DESIGN IMPROVEMENT ON BLOWER CONNECTION

Starting February 22nd, 2013, Giant Factories Inc. has improved the design of its connection to the blower unit on model **UG50-65LFPV-...** and **UG50-59LFPV-...** The connection between the wiring harness of the water heater and the blower unit is now detached from the top pan.

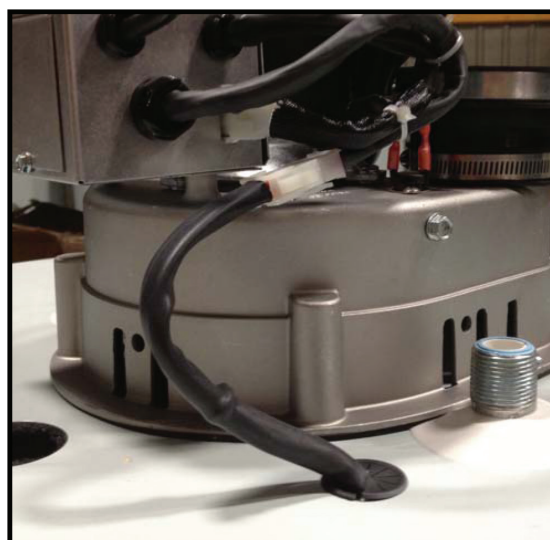
By doing so, we are avoiding a potential issue where water that could accumulate on the top pan during installation, service or operation of the water heater could infiltrate the connector that was snapped to the top pan and create a short circuit.
